ADDENDUM CC-2

February 2, 2012

PLAYER DEVELOPMENT AREA - UNIVERSITY OF OREGON
CONFORM SET:
Drawings and Specifications for Combined Contract (CC) Dated January 12, 2012

SECTION - CEILING SUPPORT
AT RISER ROOM

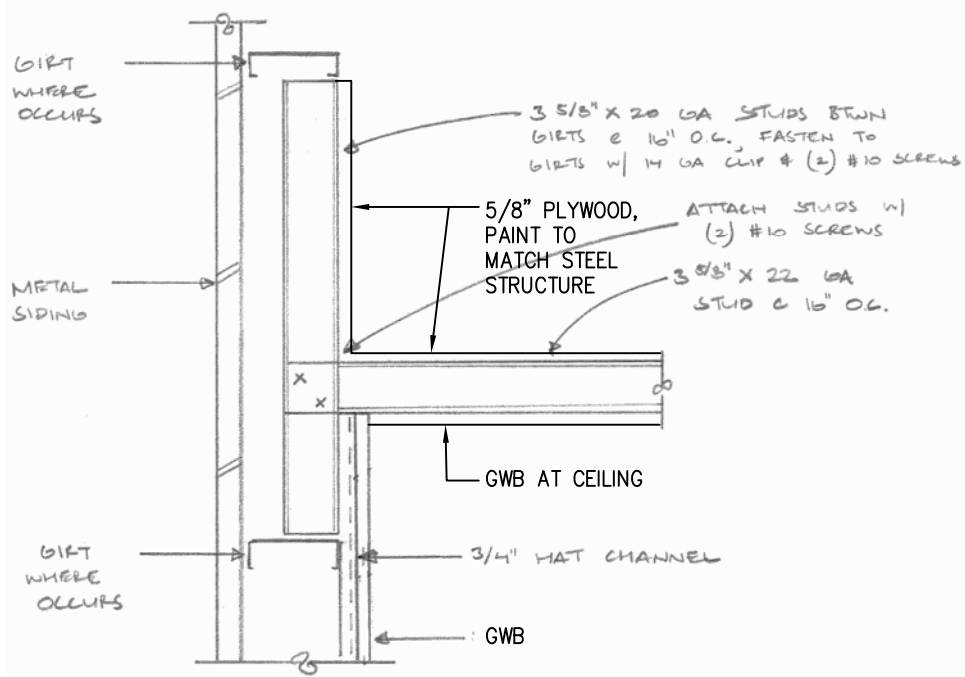
What is the required support for the GWB ceiling at the riser rm?

Answer: See revisions to drawings A1.1, A5.2, and detail 22 on sheet A10.1, as shown in **Attachment Numbers A4, A7, & A12** to this Addendum.

ITEM NO. 48 DRAWING A10.1 – BUILDING DETAILS

- 22 CONCRETE PILASTER - SEE STRUCTURAL
- 23 COLUMN SAFETY PAD. SEE GENERAL NOTES AND SHEETS A5.1, A5.2, AND A5.3 FOR VERTICAL DIMENSIONS
- 24 PROVIDE GWB OVER 3/4" METAL HAT CHANNEL, 16" O.C. AT INTERIOR WALL. SEE DETAIL 22 ON SHEET A10.1

SITE PLANS - ALTERNATE 4
PLAYER DEVELOPMENT AREA
UNIVERSITY OF OREGON

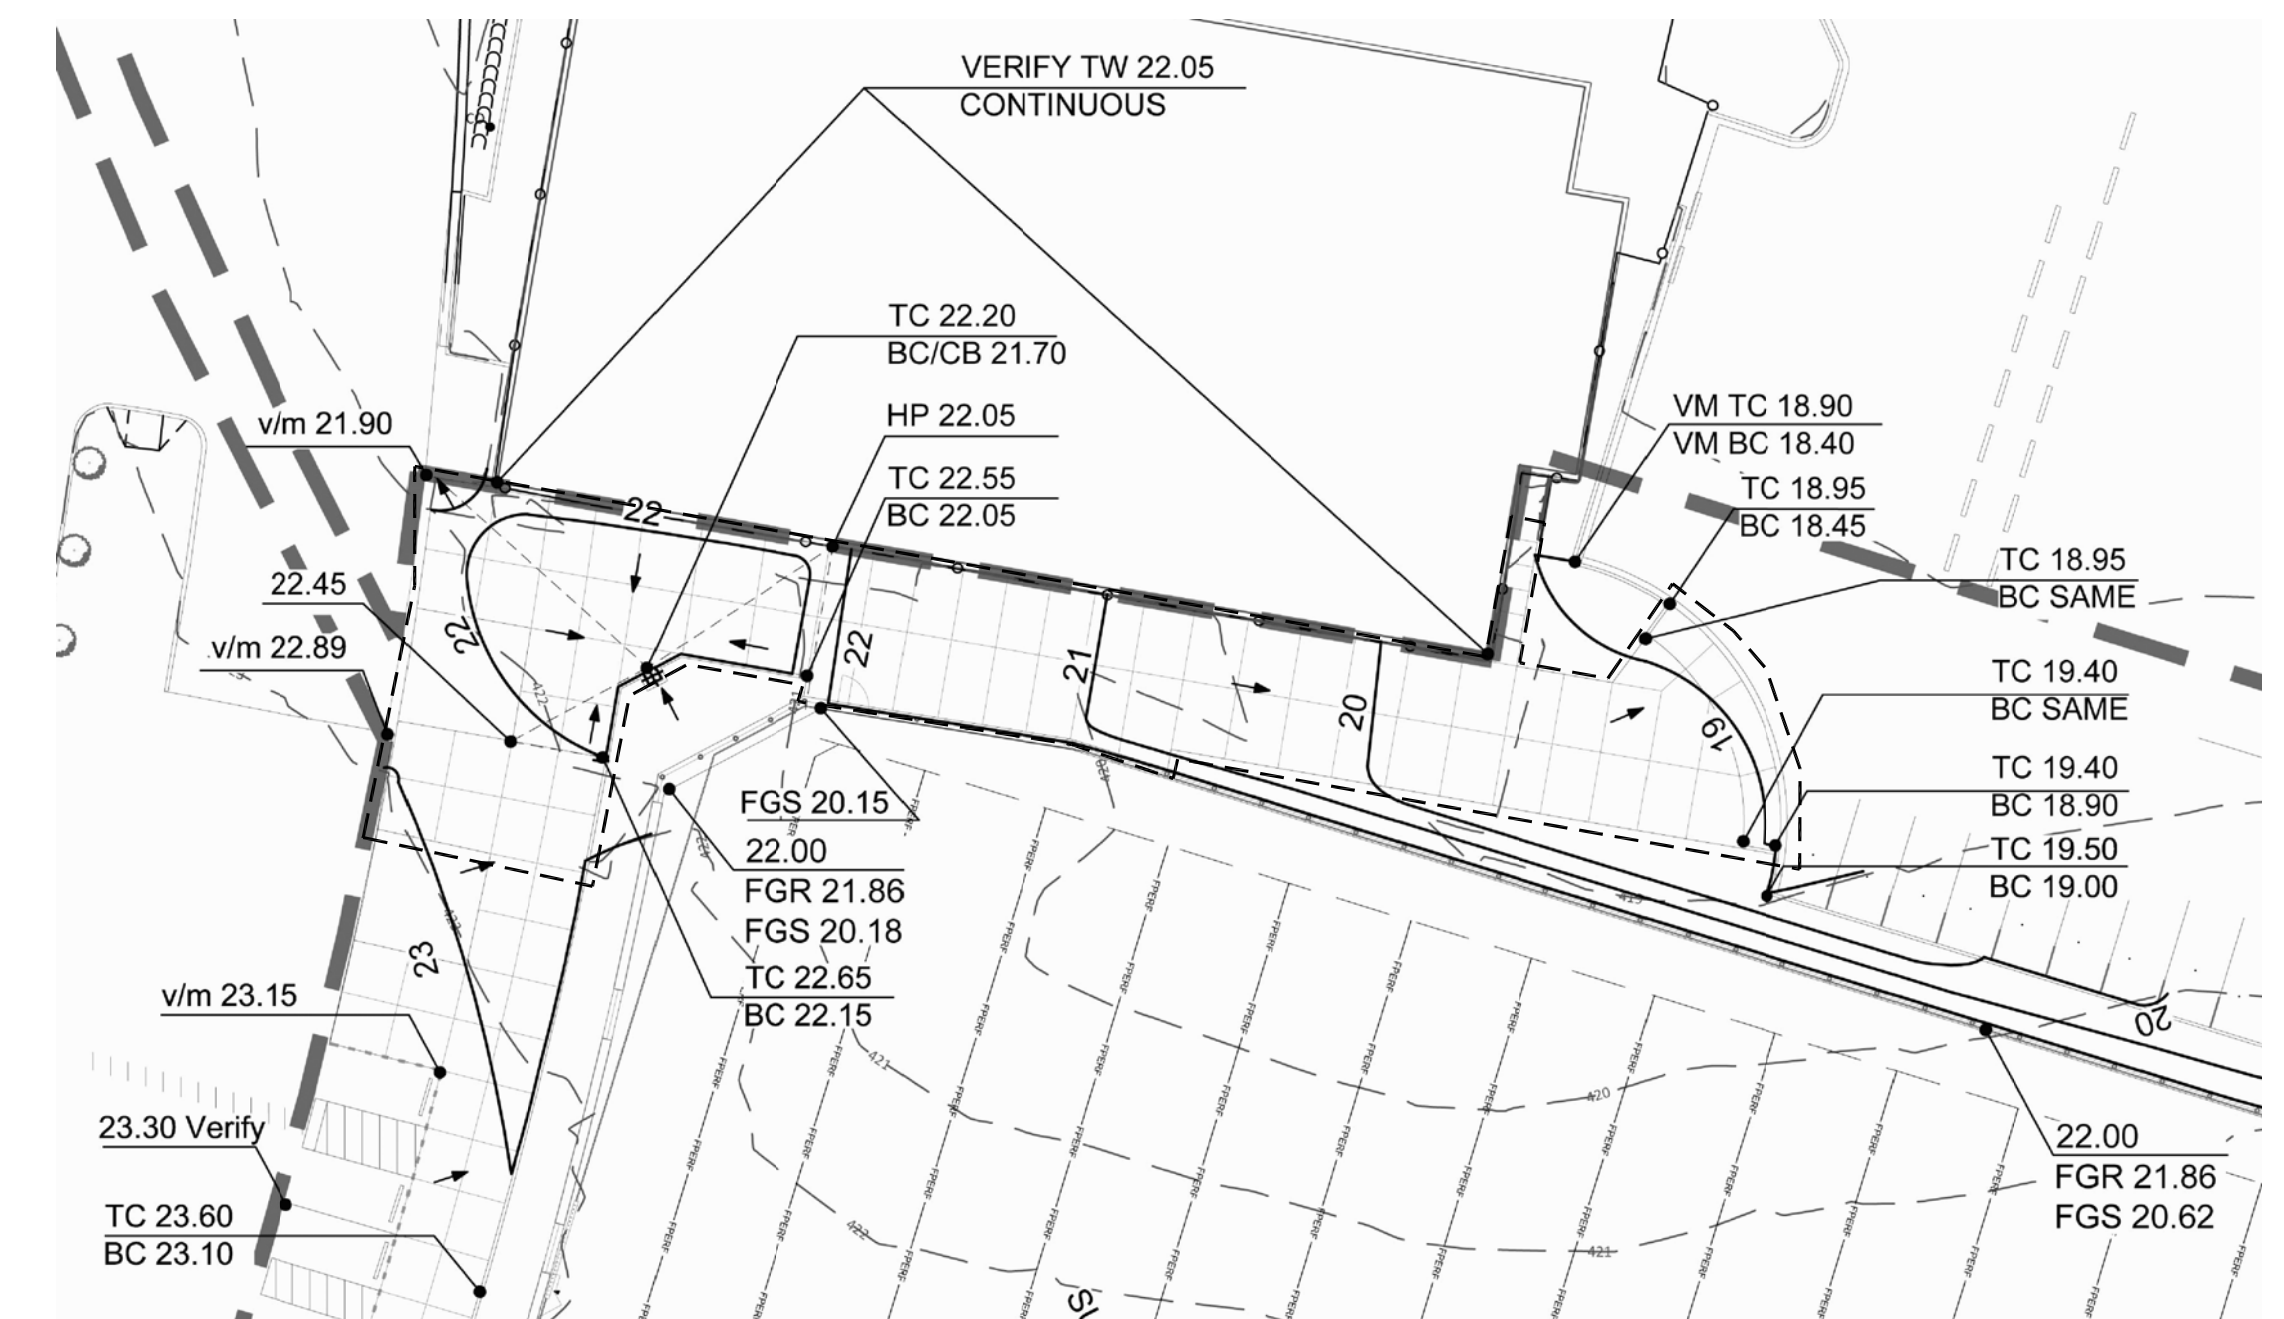
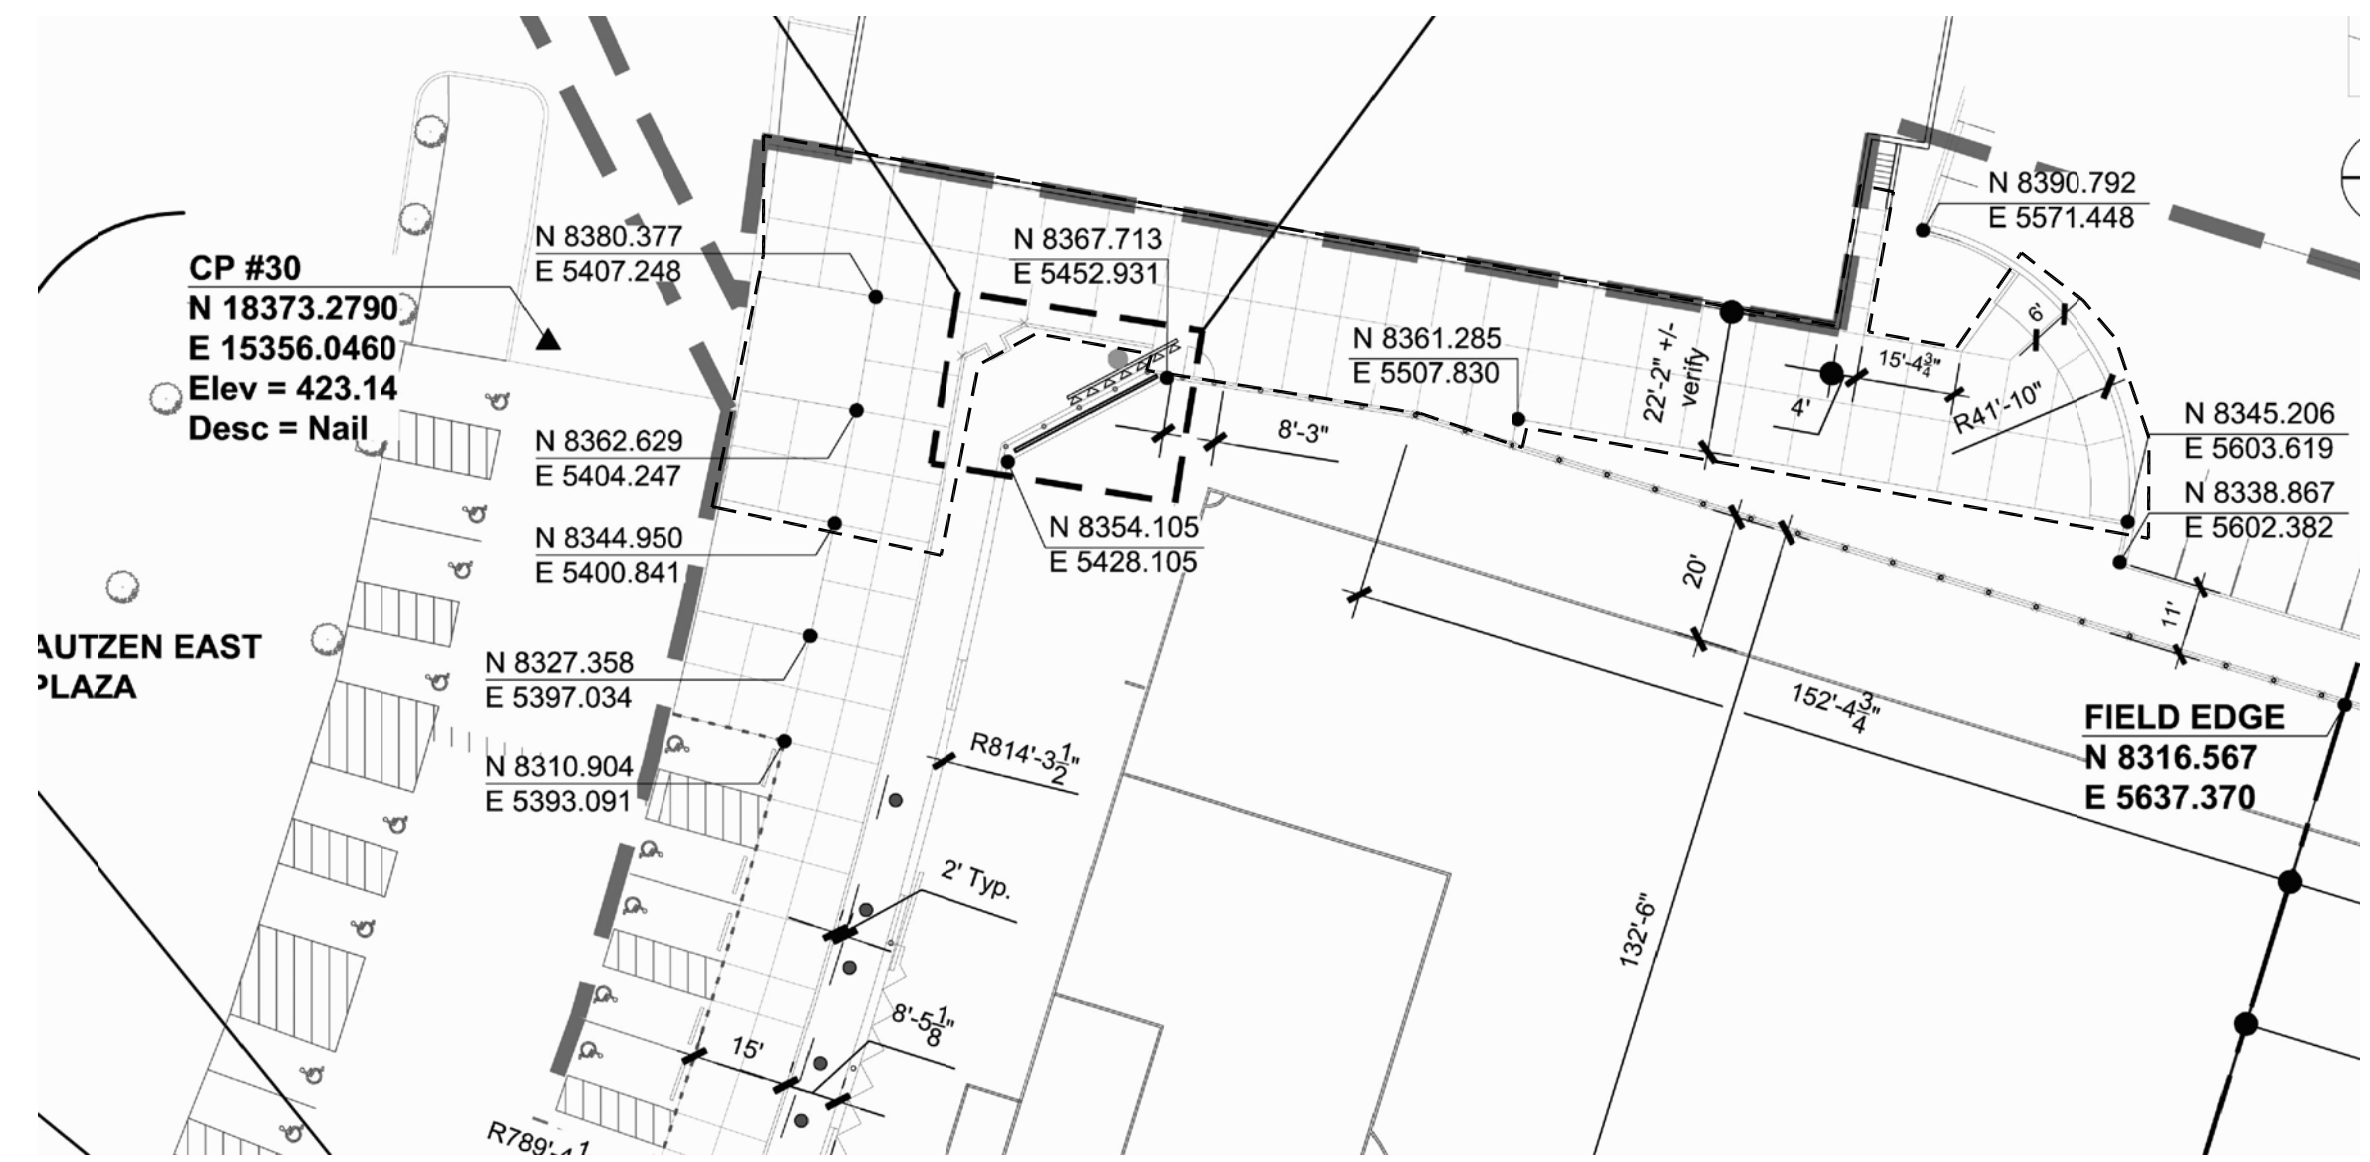
- A. Add new paragraph 3.1.D as follows:
 - D. Alternate No. 4:
 - 1. New paving and landscape modifications to the south of the Player Development Area building. See drawings AS1.1 and AS1.2 added by Addendum CC-2 dated February 2, 2012.

ITEM NO. 49 DRAWING AS1.1 - SITE PLANS - ALTERNATE 4
